**BEDFORD REGIONAL WATER AUTHORITY
SMITH MOUNTAIN LAKE WTP &
RAW WATER PUMPING STATION / INTAKE
ELECTRICAL
INTAKE STRUCTURE
SITE PLAN**

BEDFORD REGIONAL WATER AUTHORITY
SMITH MOUNTAIN LAKE WTP &
LAKES TO FOREST WATER LINE EXTENSION
ELECTRICAL
MEMBRANE/ADMIN BUILDING
PARTIAL POWER PLAN

BEDFORD REGIONAL WATER AUTHORITY SMITH MOUNTAIN LAKE WTP & LAKES TO FOREST WATER LINE EXTENSION ELECTRICAL MEMBRANE/ADMIN BUILDING UNDER SLAB CONDUIT ROUTING POWER PLAN		DESIGNED: ZKO DETAILER: RTD CHECKED: SDS APPROVED: DATE: 01/11/16	PROJECT NO. 182262 E-30-407 SHEET OF
BLACK & VEATCH Building a world of difference. Black & Veatch Corporation Virginia Beach, VA		ISSUED FOR CONSTRUCTION REVISIONS AND RECORD OF ISSUE NO. BY CHK APP 0 ZKO SDS DATE 11/11/16 DWG: C:\DW\Working\Unw\americas\182262\182262-E-30-MEMBRANE.BV.rvt XREF1: XREF2: XREF3: XREF4: PLOTTED: 1/12/2016 10:49:29 AM USER:	SCOTT D. STOKKAN Lic. No. 0402-032019 1/1/2016 PROFESSIONAL

1 LIGHTING PLAN - OPERATING FLOOR
1/8" = 1'-0"

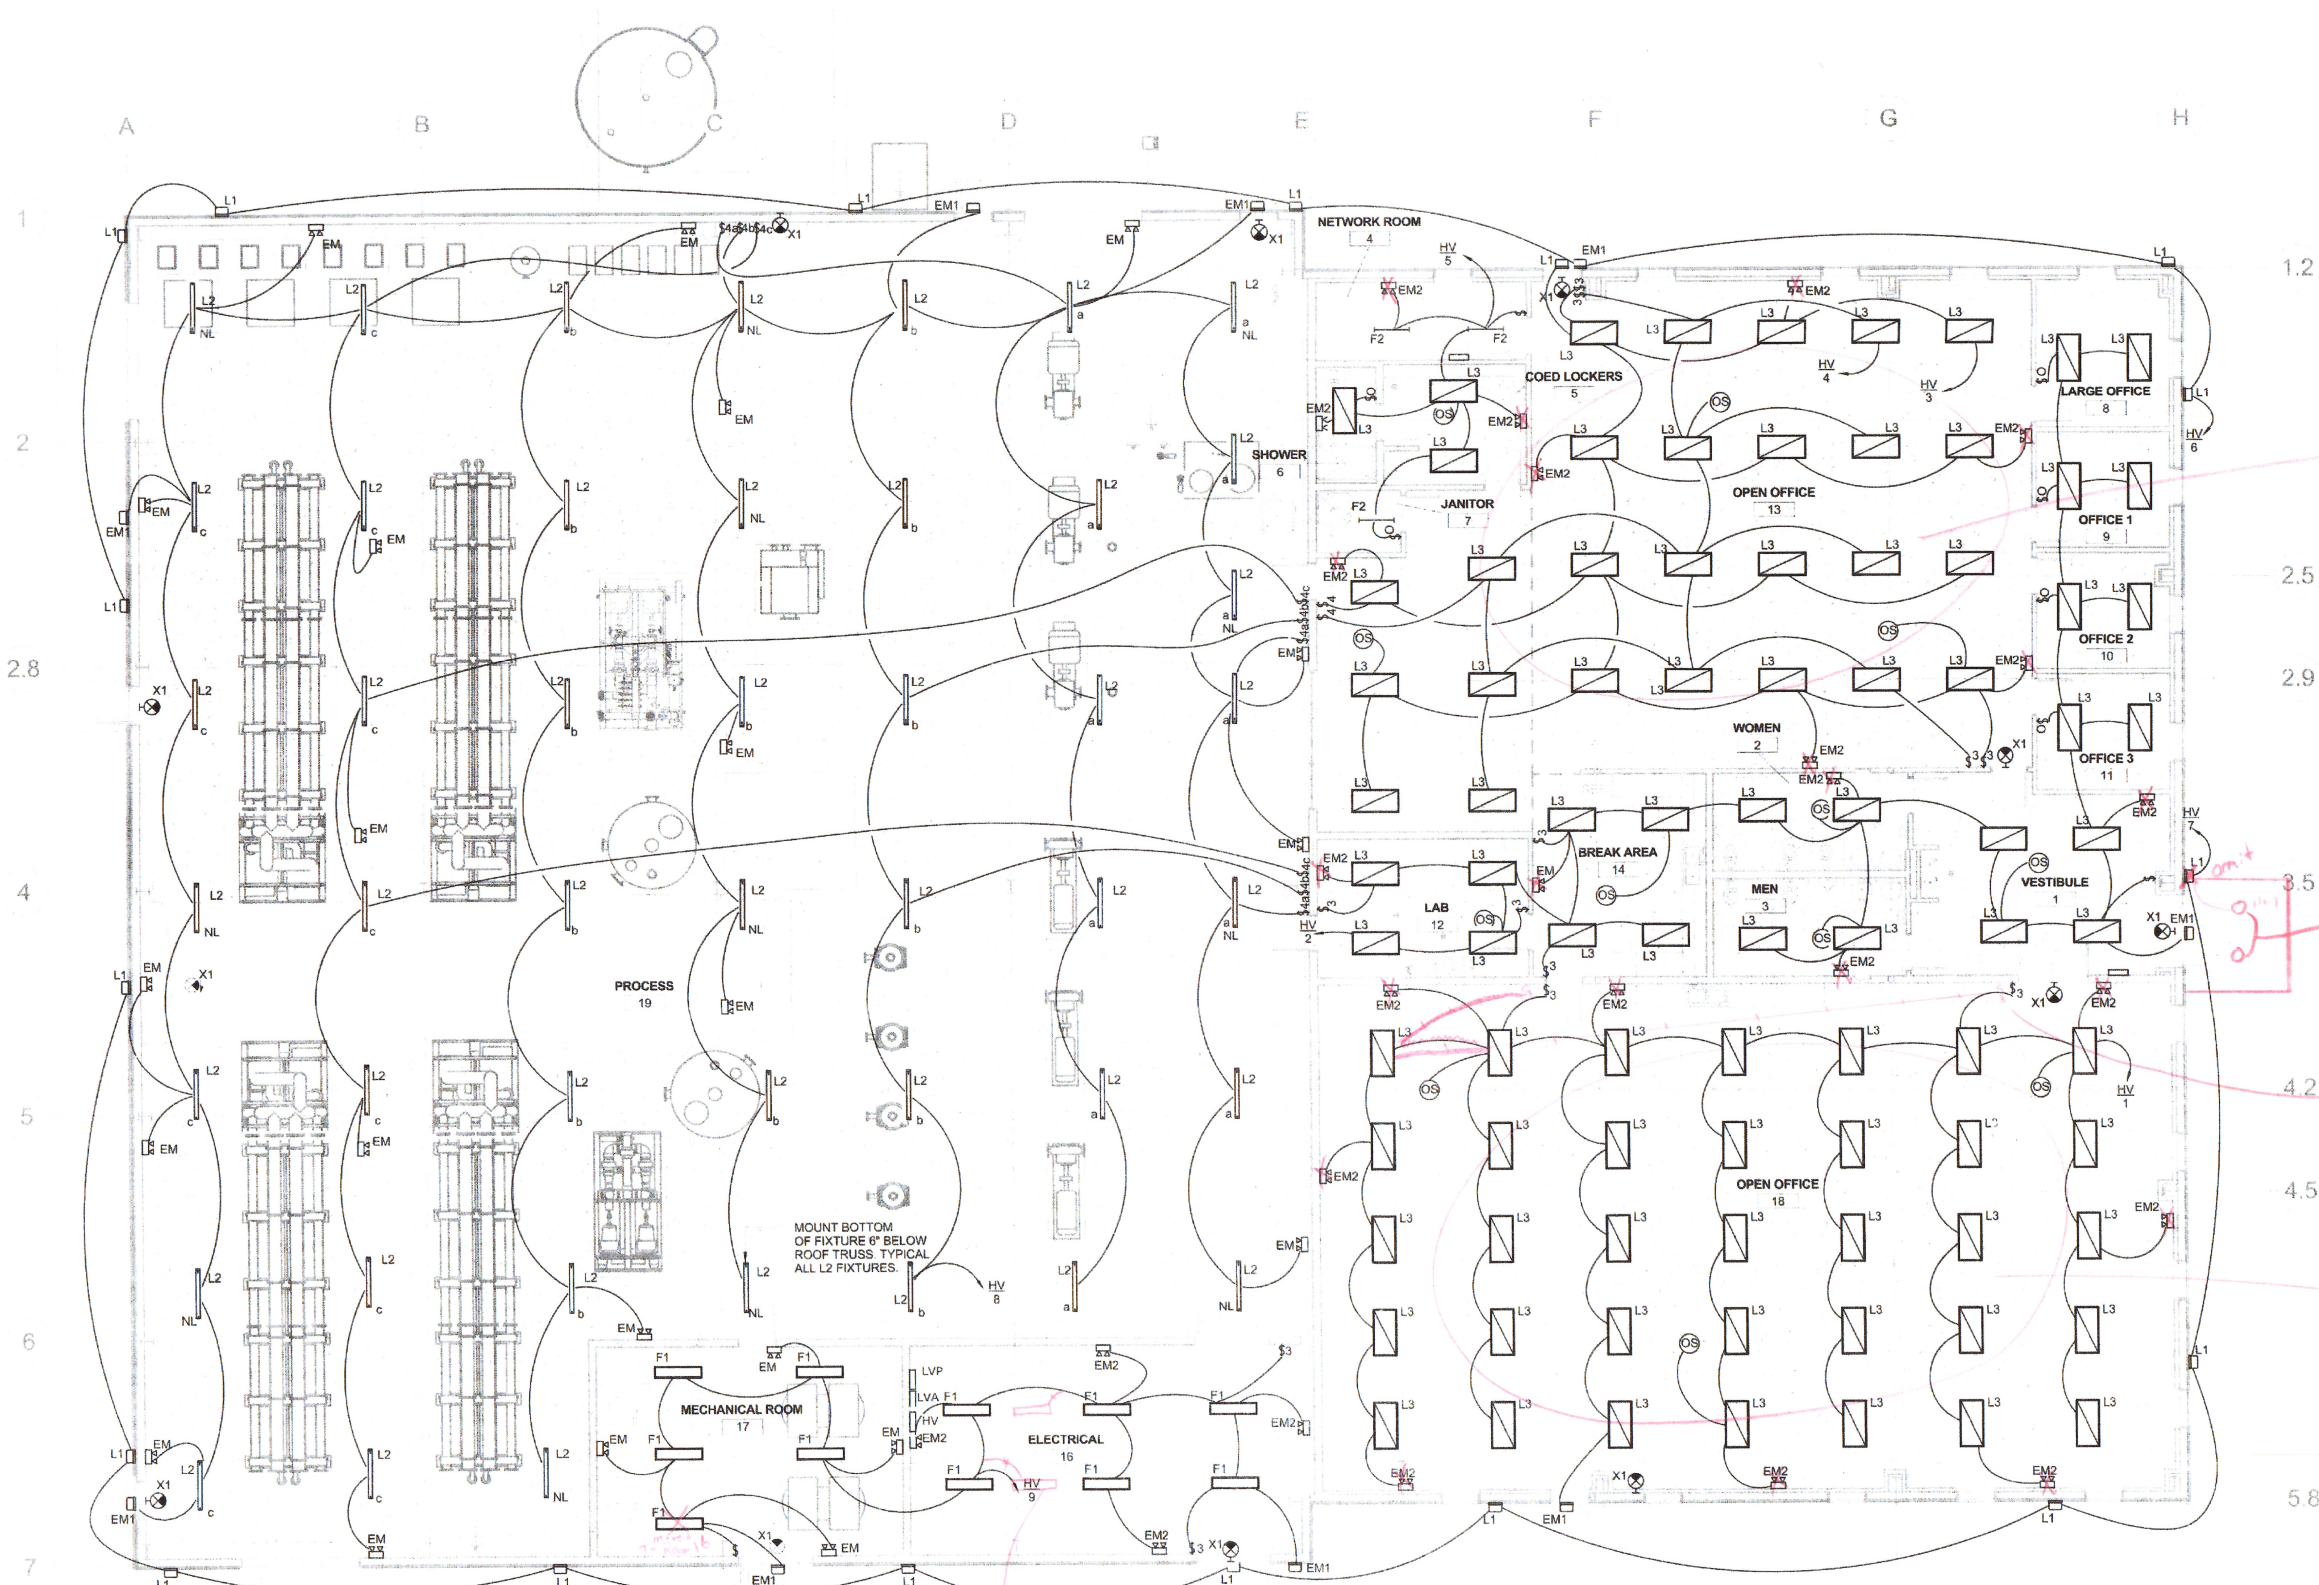
New Lighting Layout on Following Page

Area 2, stay within for Regular Plan of Lights

New Lighting Layout on Following Page

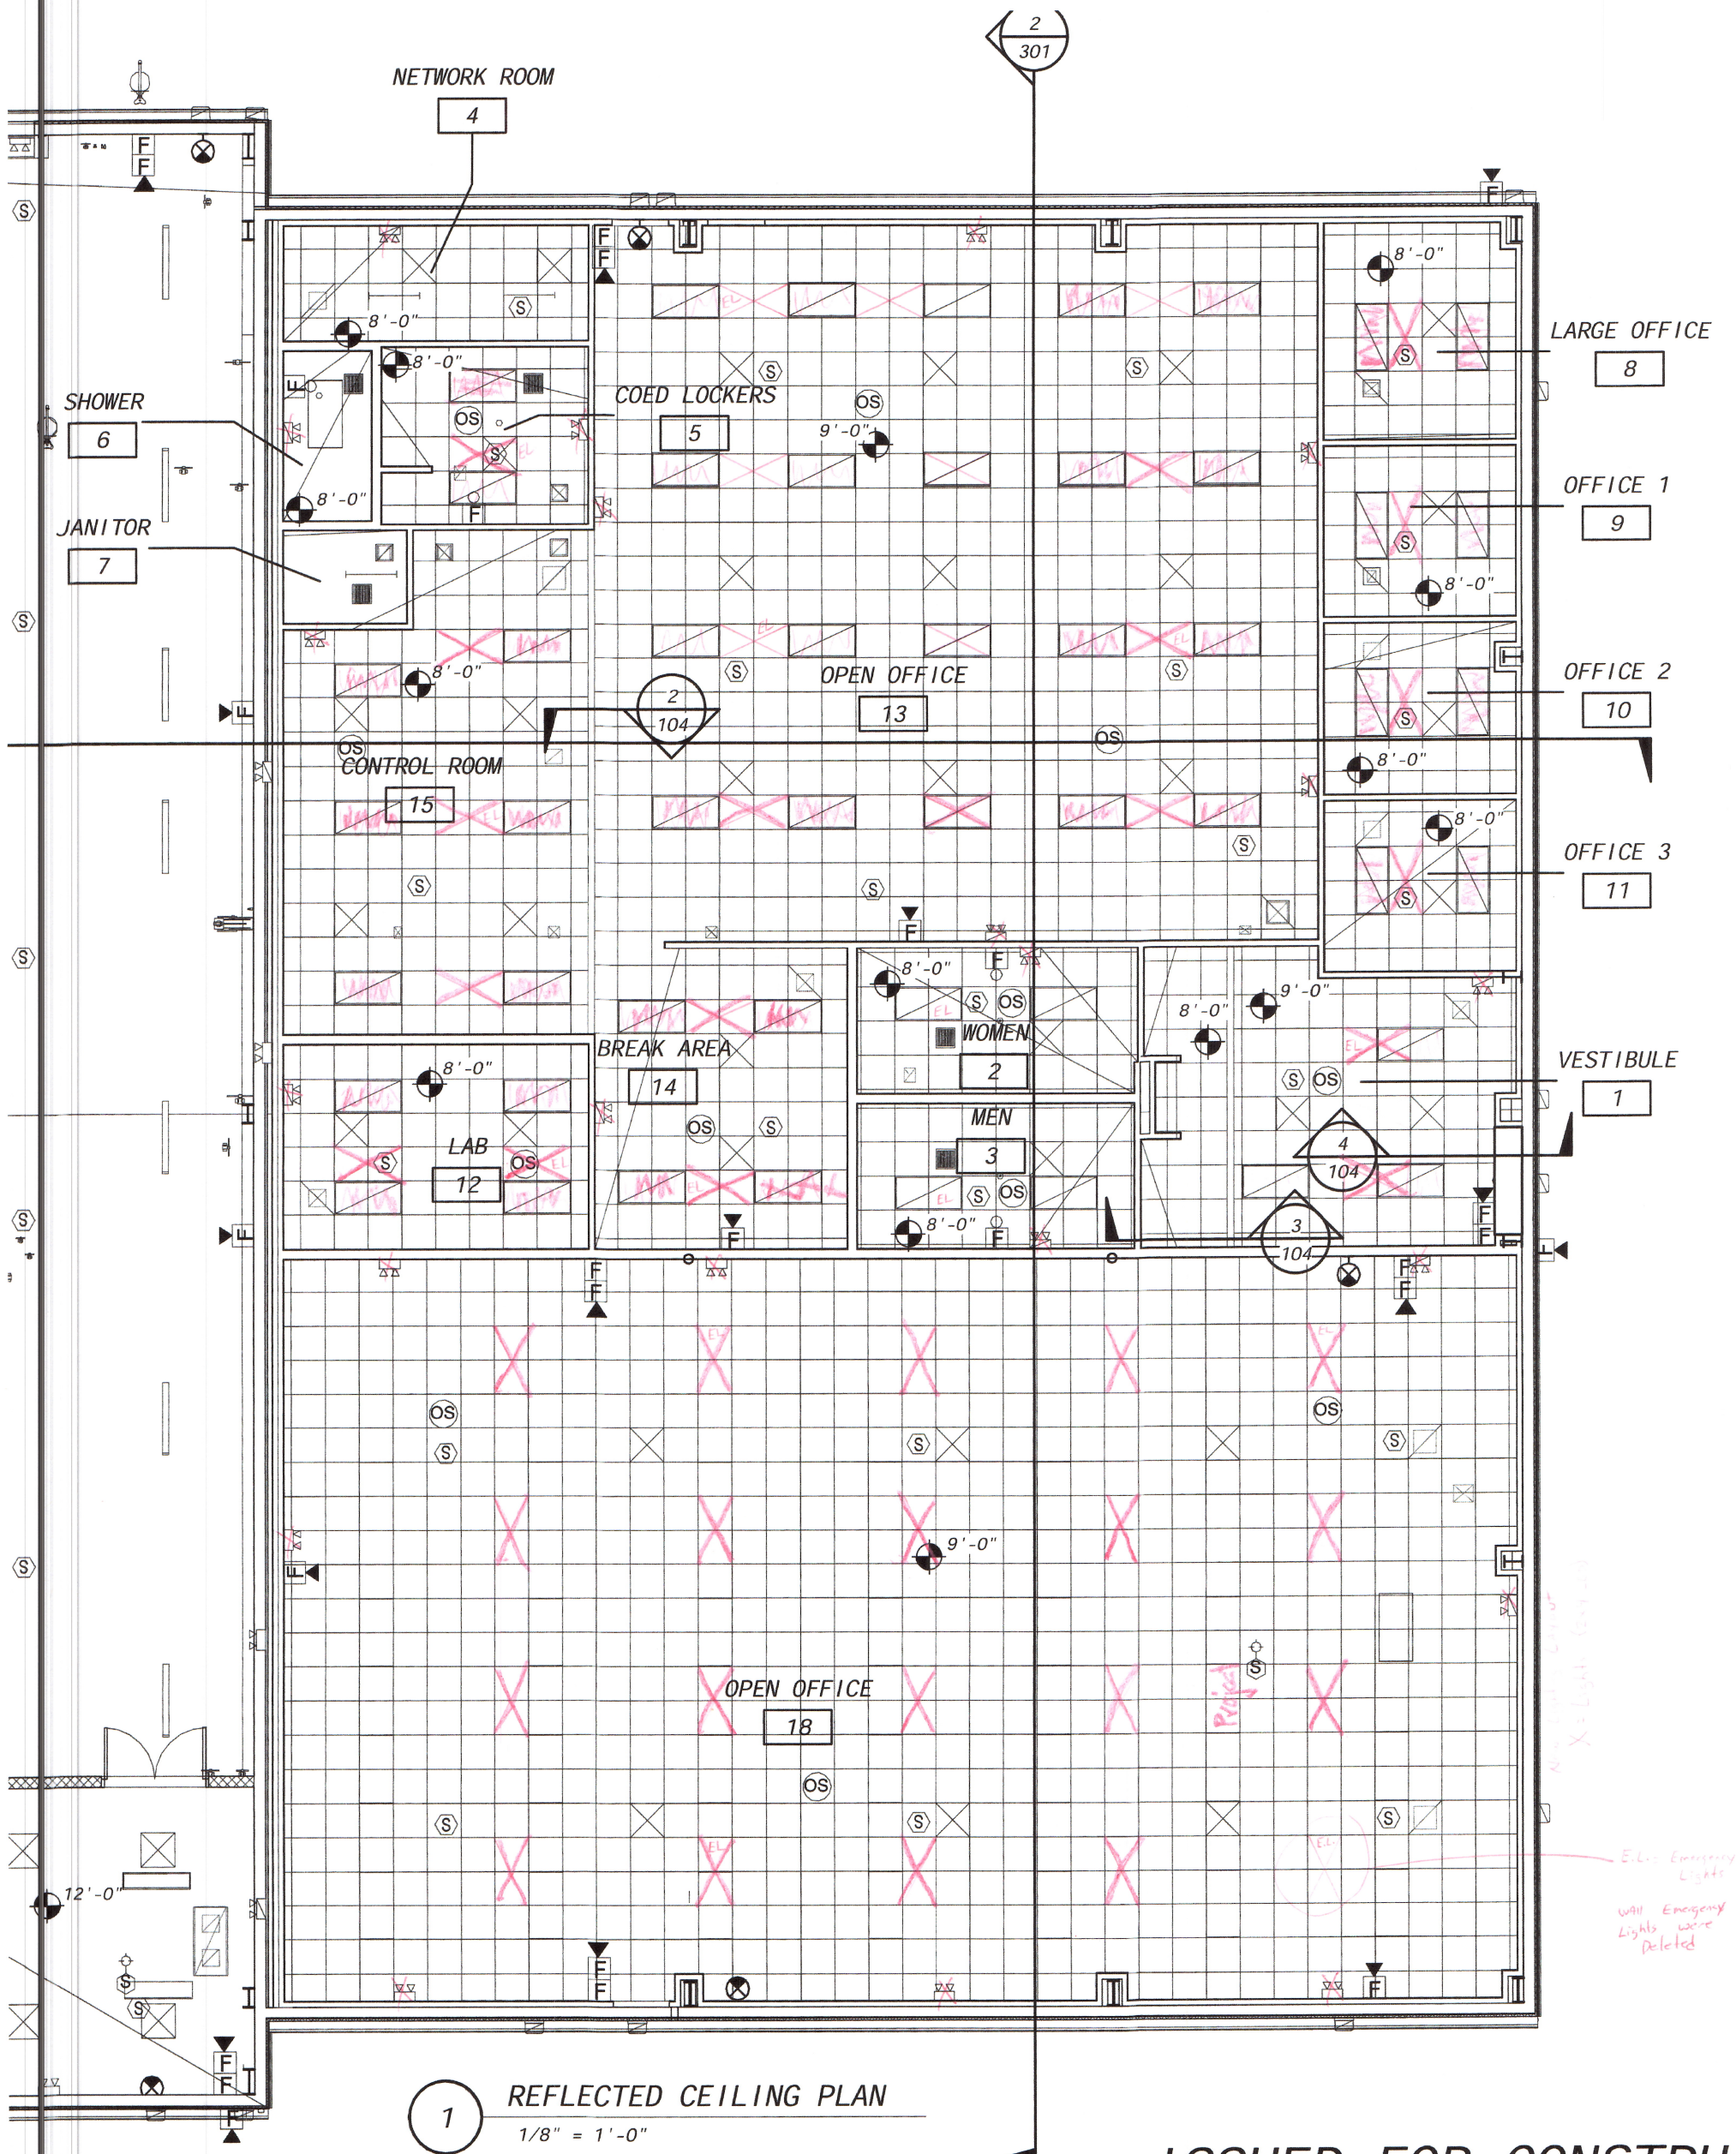
LVP = Now IS LP-C
LVA = Now IS LP-B

NEW Electrical Room Layout

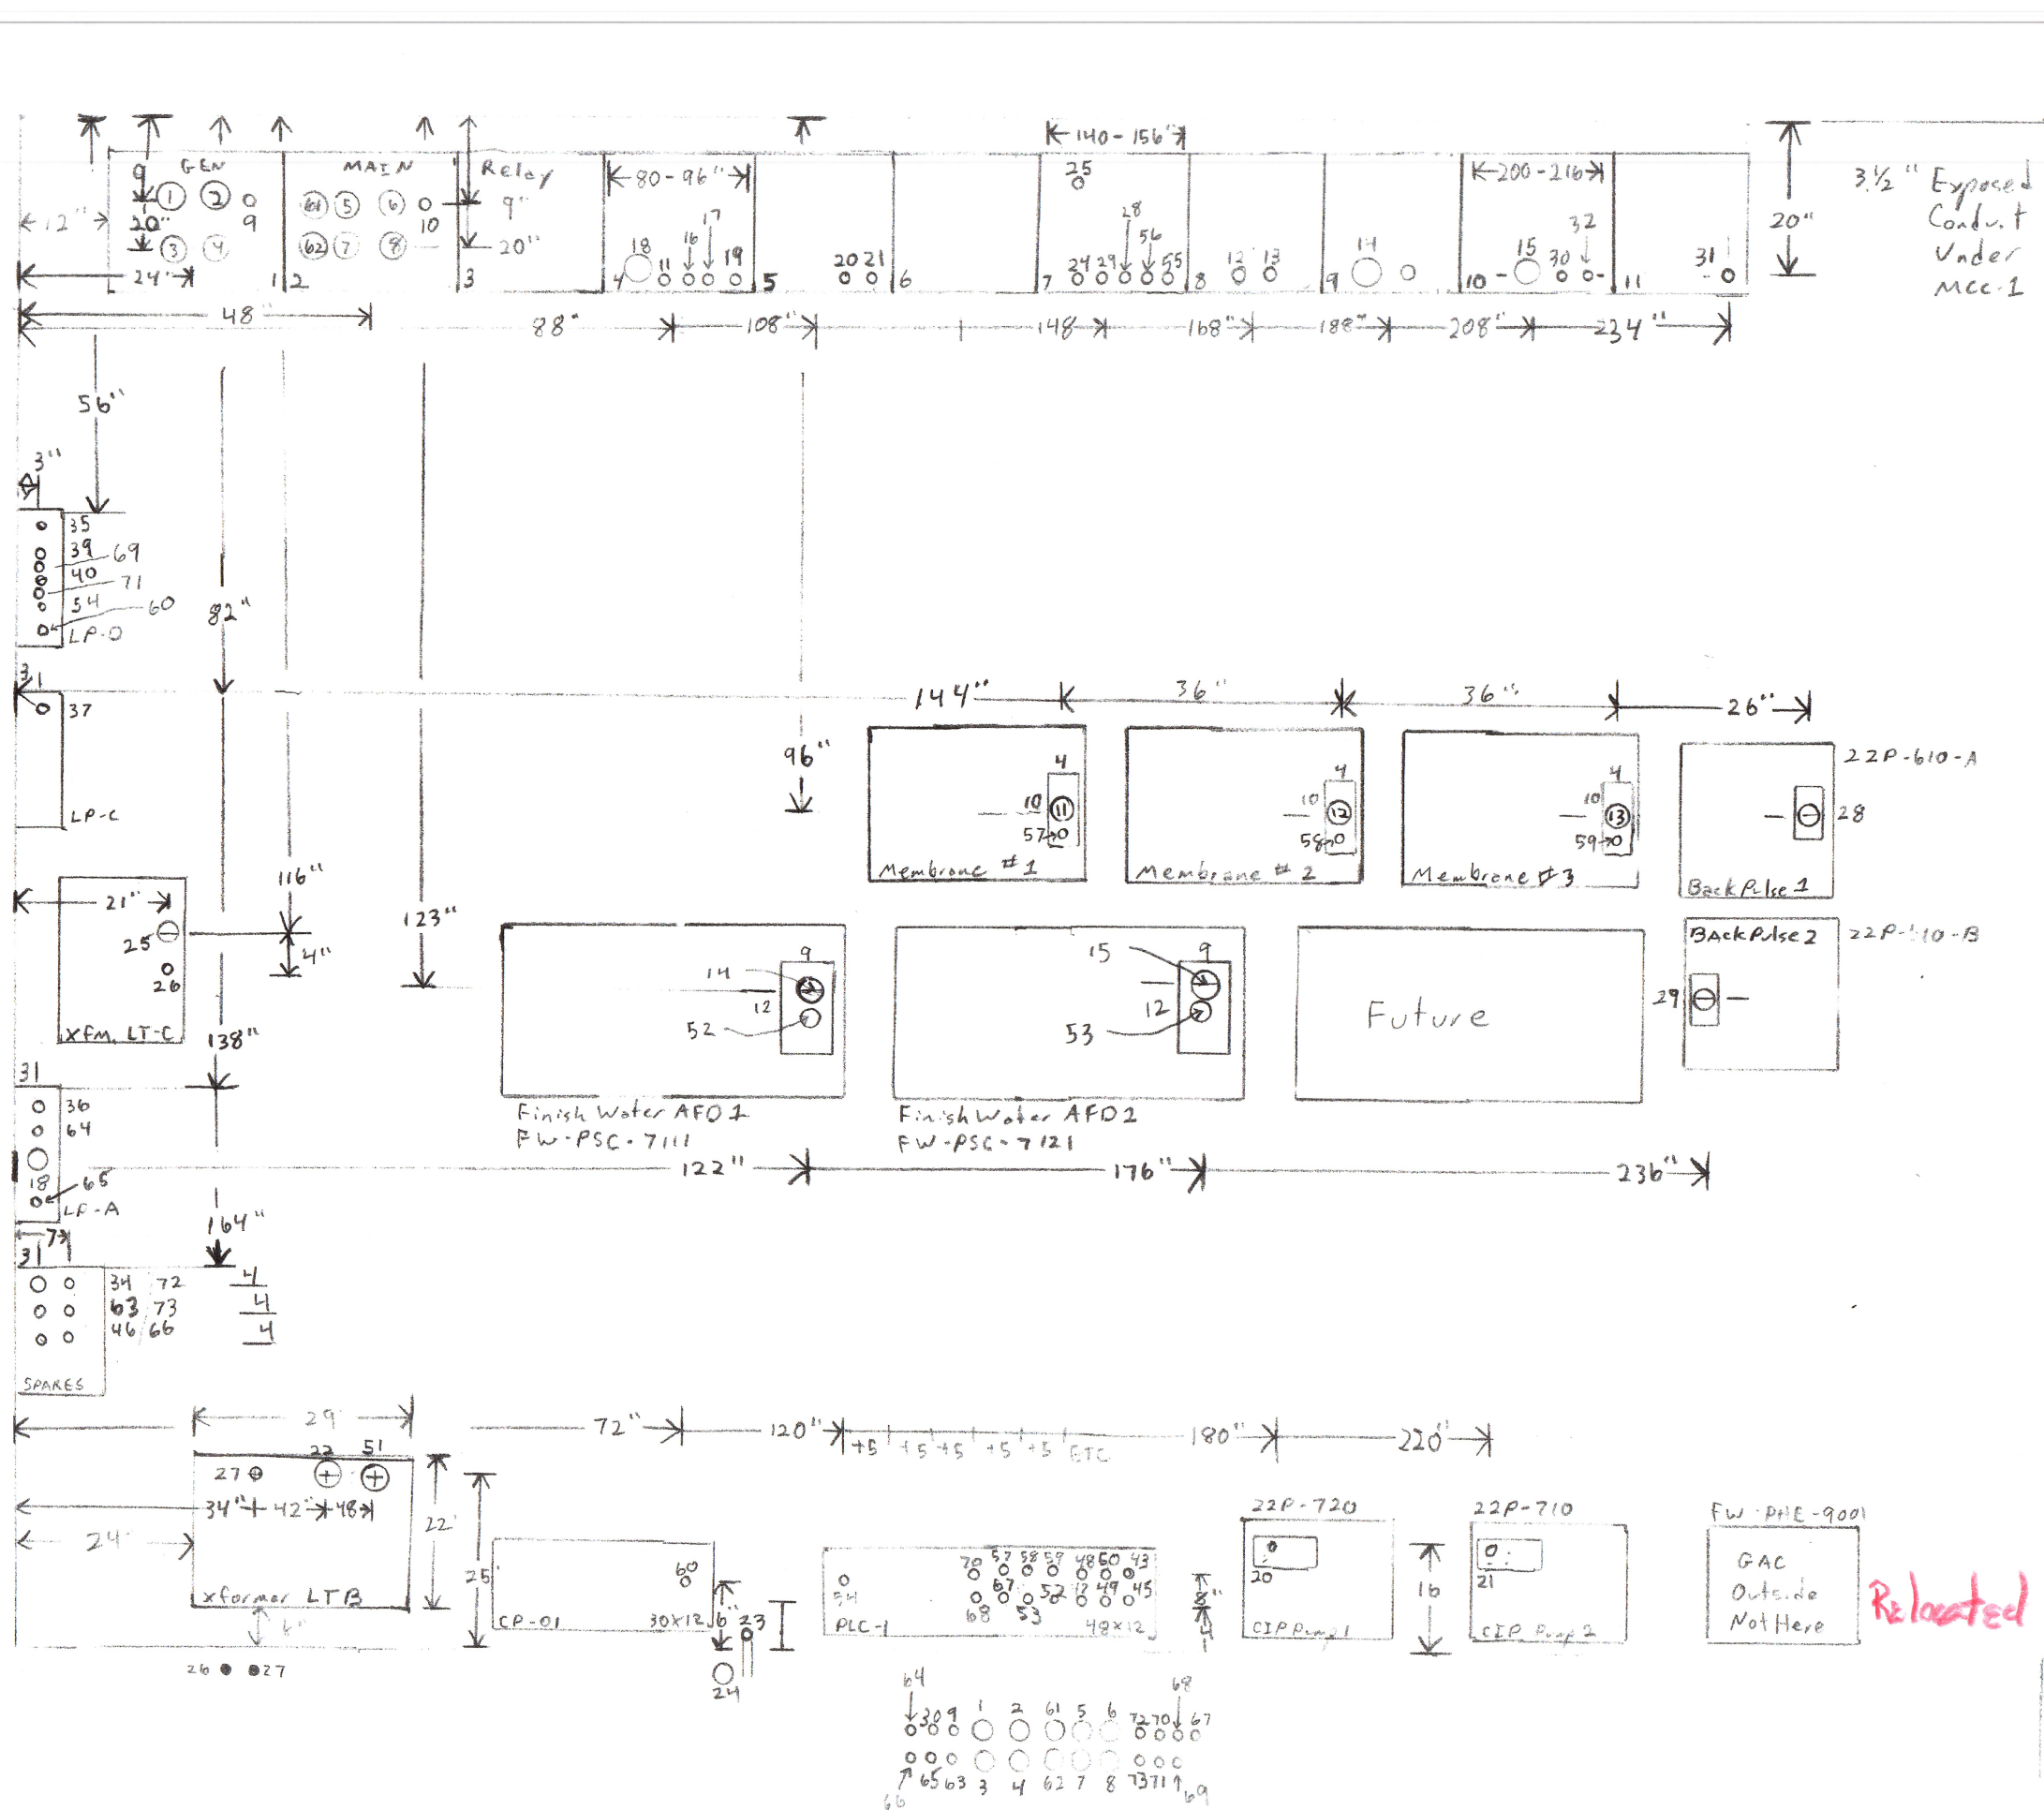
GARAGE Details
